New Albany Architectural Review Board Meeting Agenda
Monday, March 13, 2023 7:00pm

LOCATION: 266 East Main Street (PID: 222-000089)
APPLICANT: Sarasheen Partnership LLC, c/o Tom Sheehan
REQUEST: Certificate of Appropriateness
ZONING: Infill Planned Unit Development (I-PUD) within the Urban Center
STRATEGIC PLAN: Village Center
APPLICATION: ARB-22-2023

LOCATION: 7600 Fodor Road (PID: 222-000922)
APPLICANT: Anders Samuelson, Mannik Smith Group
REQUEST: Certificate of Appropriateness
ZONING: Urban Center District within Village Center – Campus Subdistrict
STRATEGIC PLAN: Village Center
APPLICATION: ARB-33-2023

LOCATION: Taylor Farm Park (PID: 222-005165)
APPLICANT: City of New Albany c/o Adrienne Joly
REQUEST: Certificate of Appropriateness
ZONING: Agricultural (AG)
STRATEGIC PLAN: Parks and Green Space
APPLICATION: ARB-34-2023

SITE PLAN &
 LANDSCAPE PLAN

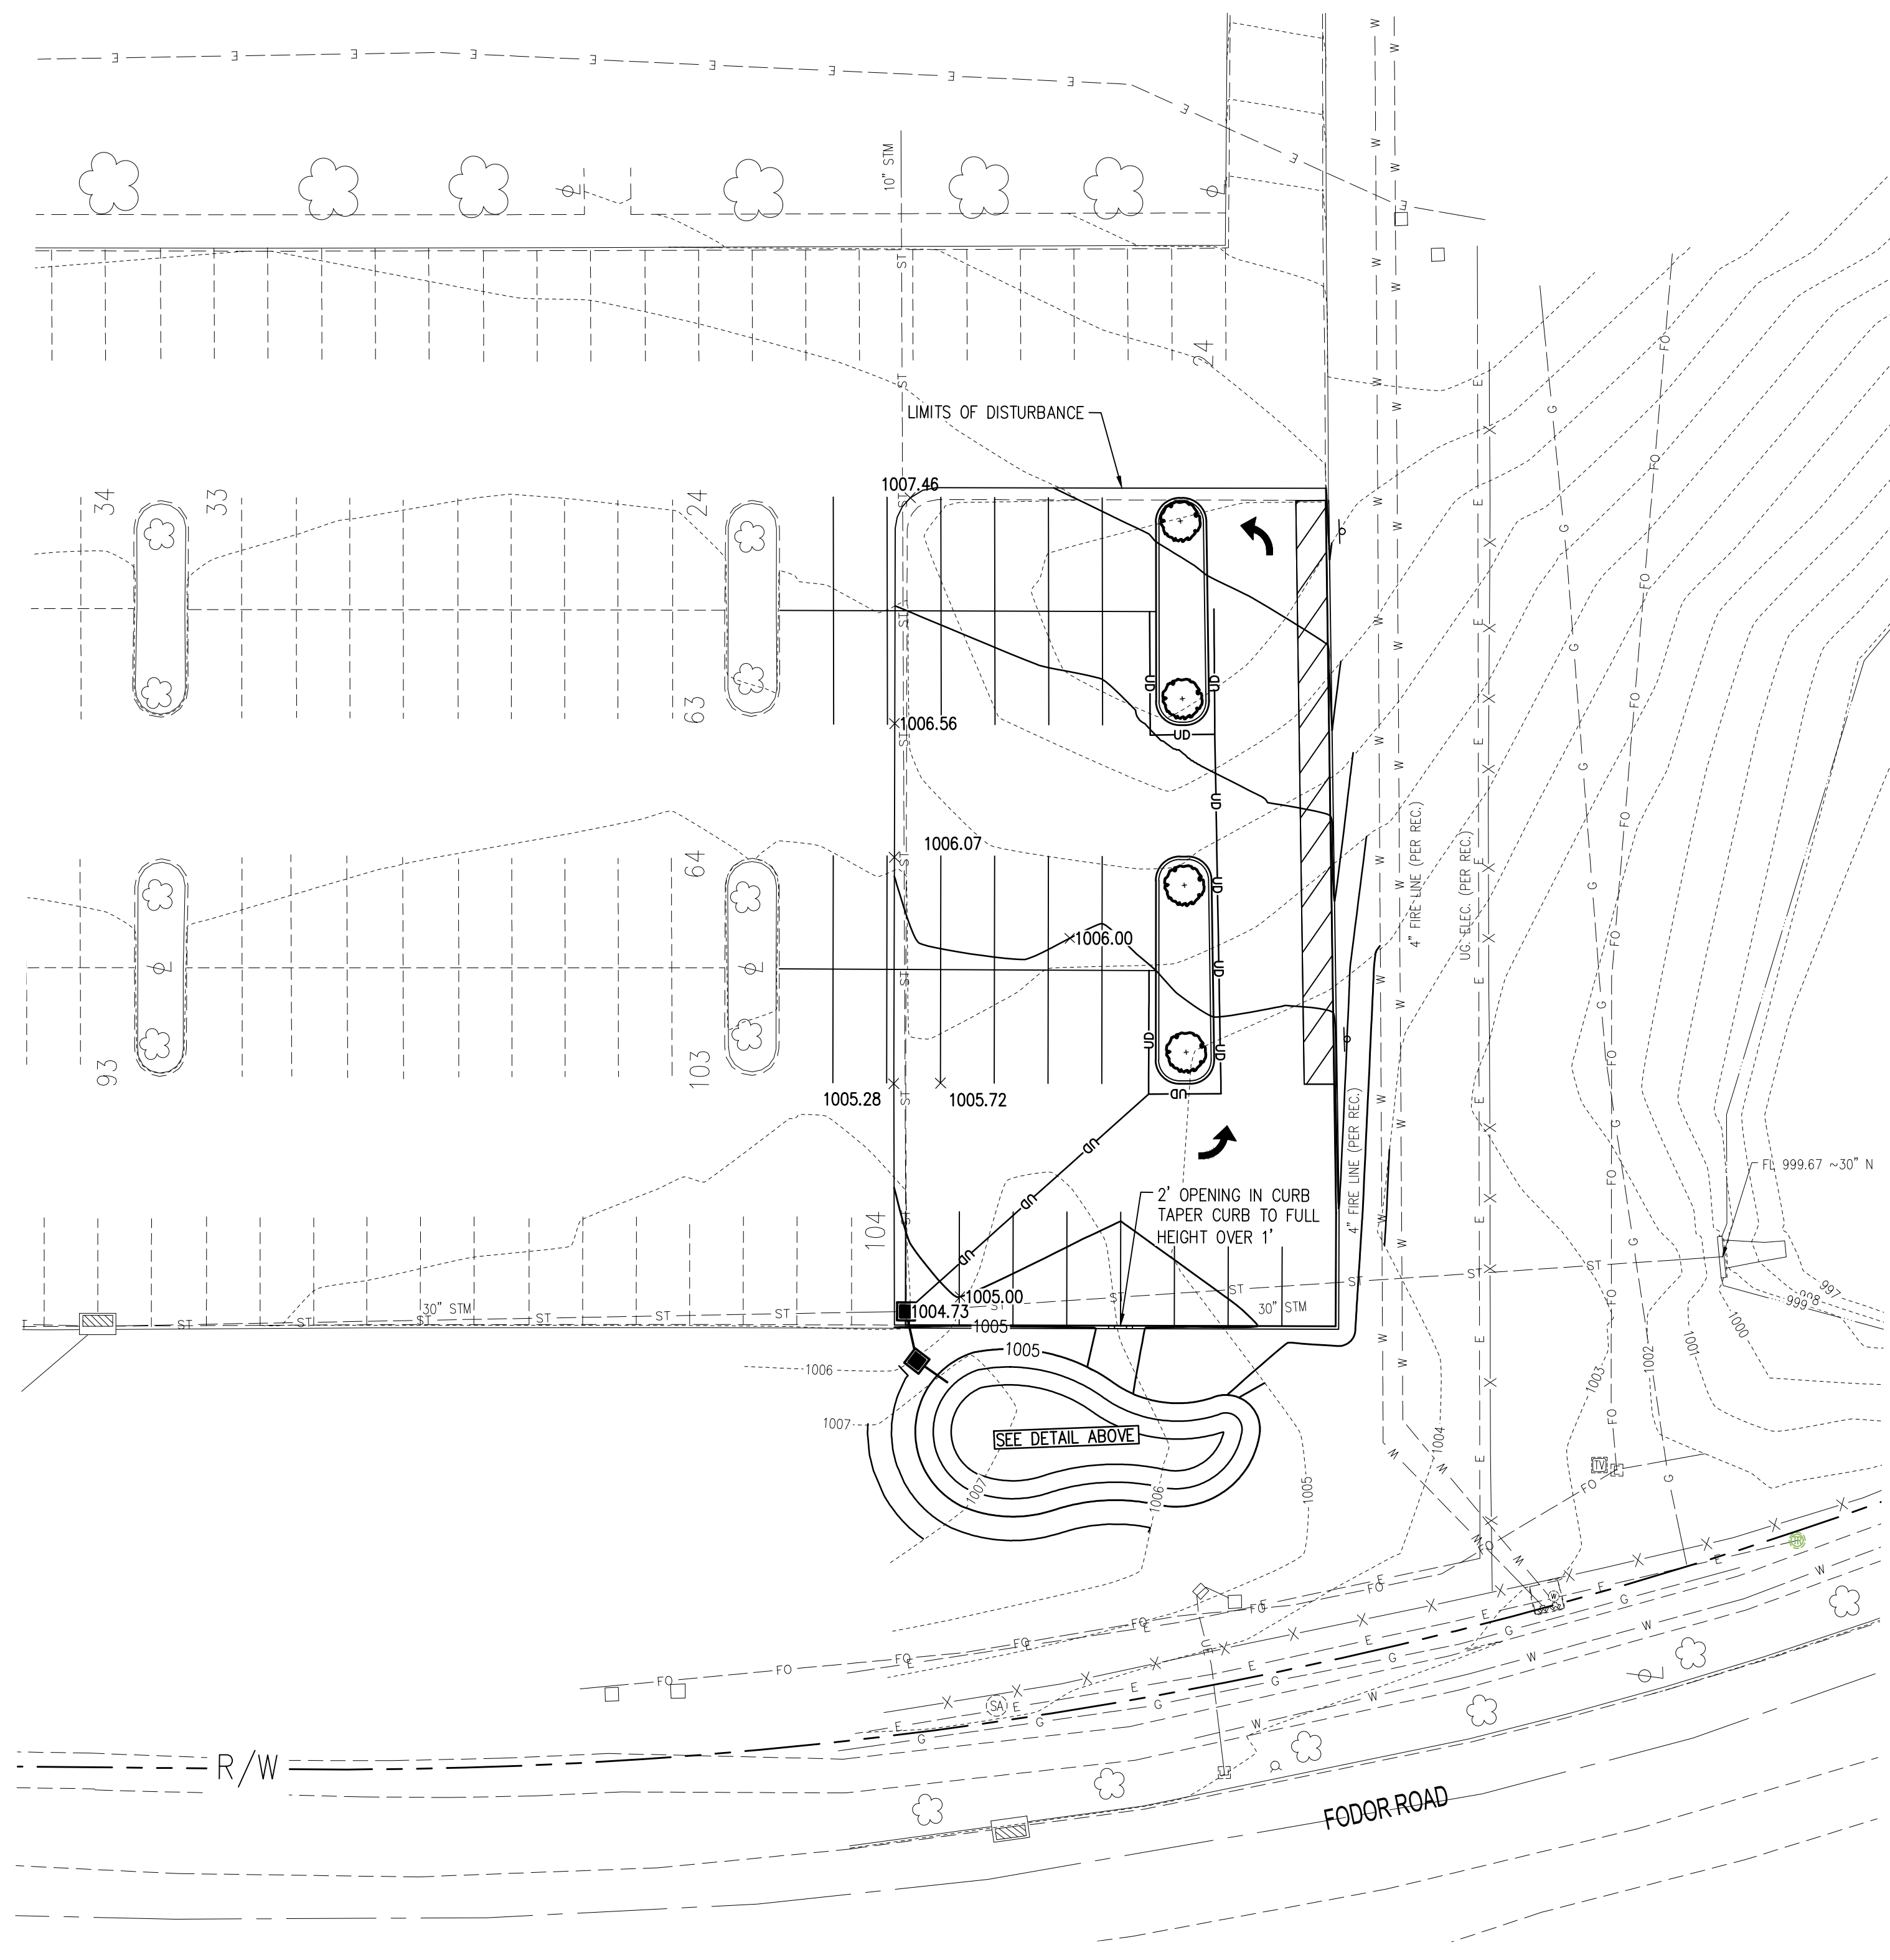
- Landscape:
 - The parking lot is landscaped to meet code chapter 1171.06(b) which requires “parking lots shall be screened from primary streets, residential areas, and open space by a three and one-half (3.5)-foot minimum height evergreen hedge or masonry wall, or combination of wall and plantings. The parking lot expansion is located along Fodor Road and is screened by evergreen shrubs.

- Codified Ordinance 1171.08(a) requires “wet and dry stormwater basins shall be designed by a landscape architect in conjunction with a professional engineer to ensure that the basins have a natural shape and are graded and planted in an attractive manner.” The basin is designed with a natural curvature shape and is planted with a ornamental grasses, perennials, and evergreen shrubs.

- The additional parking utilizes the current circulation plan for the High School parking lot and routes incoming traffic from Fodor Road to the right to maximize stacking and increase the drop-off area near the building by creating a one-way counterclockwise loop to increase on-site safety. The additional spaces extend this circulation route.

2 Garden Elevation
Scale: 1/8" = 12'

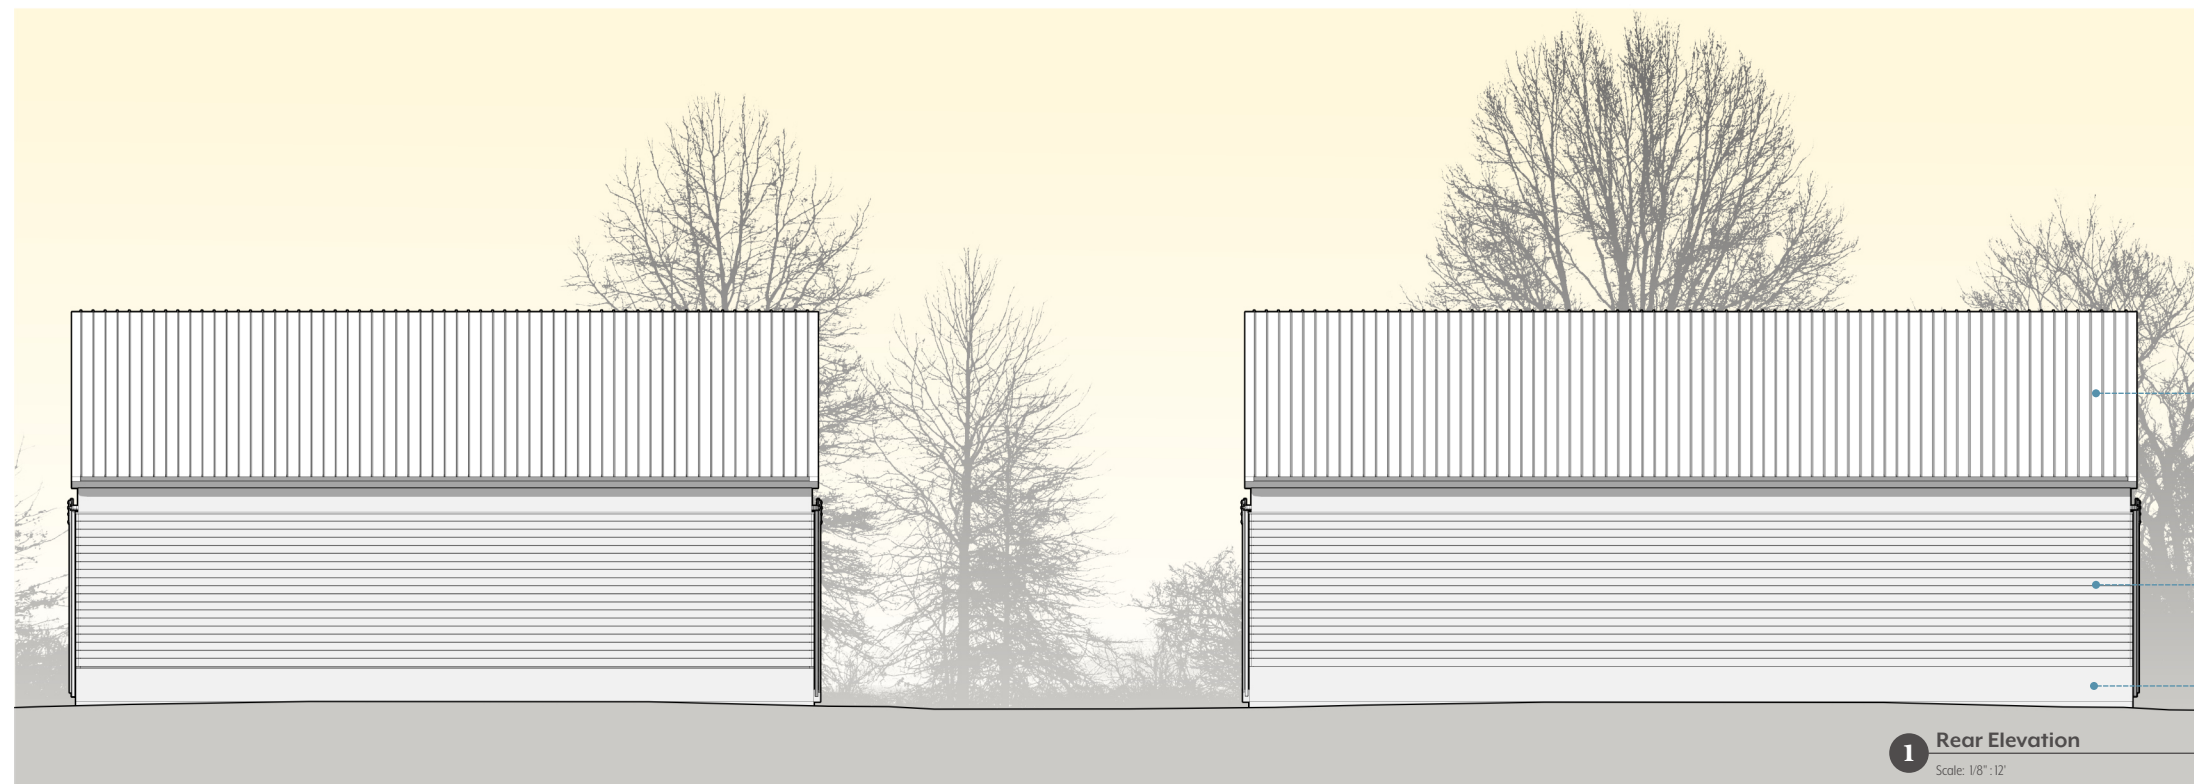
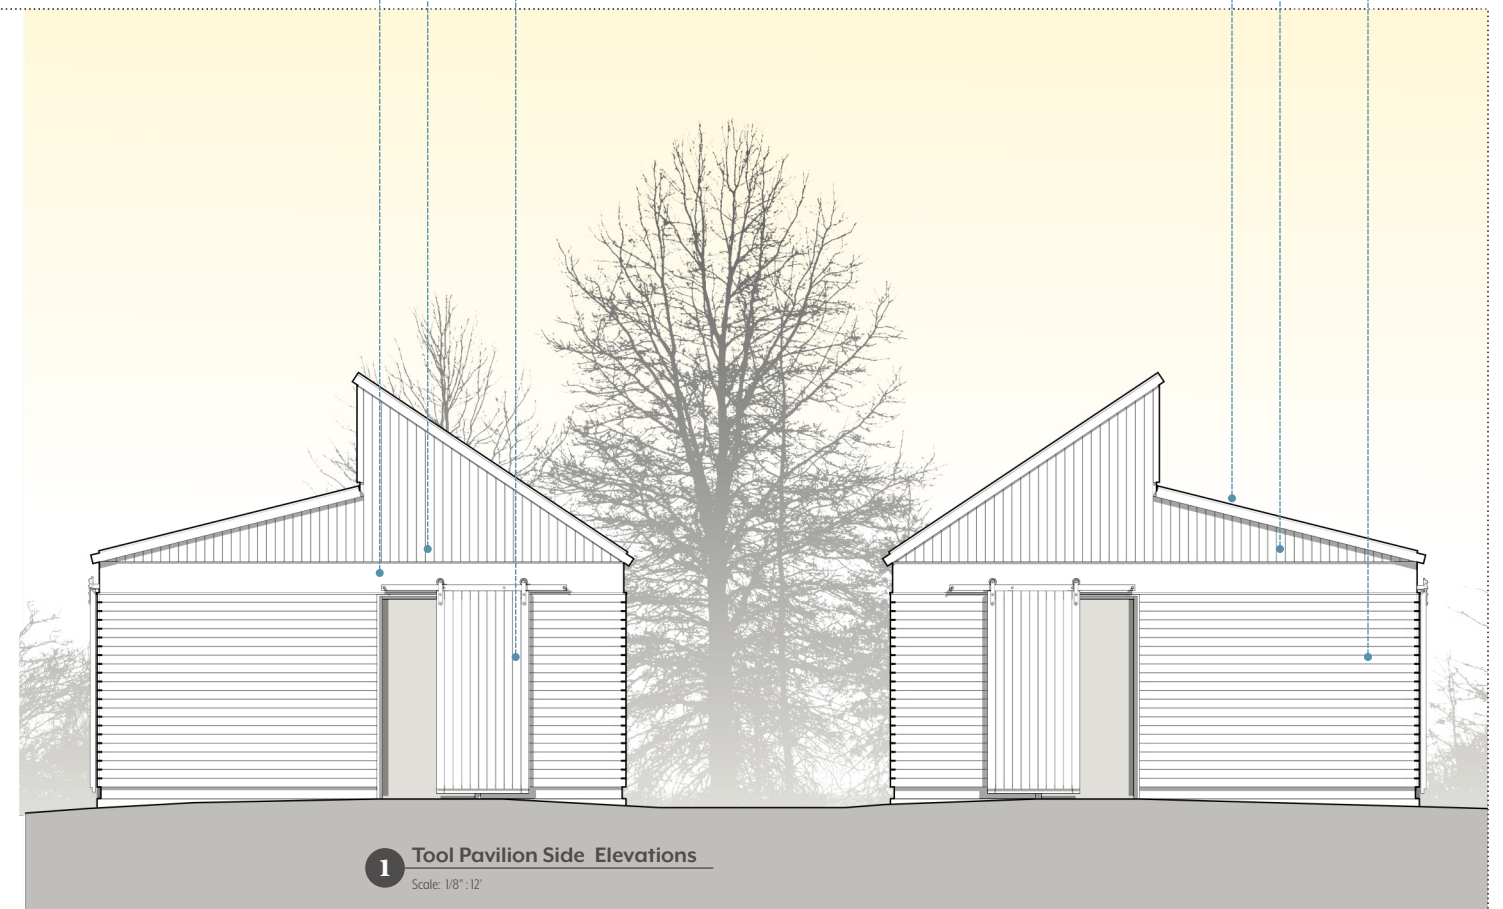
- The applicant identifies the following exterior materials on the plans:
 - Dark wood siding;
 - CMU;
 - Steel roof panels; and
 - Fixed wood windows
2. *The visual and functional components of the building and its site, including but not limited to landscape design and plant materials, lighting, vehicular and pedestrian circulation, and signage.*

- Four gooseneck, downcast lights are proposed to be added above the entrances to each building. The proposed fixtures are appropriate as they are not excessive and simply assist with ingress and egress of the buildings.
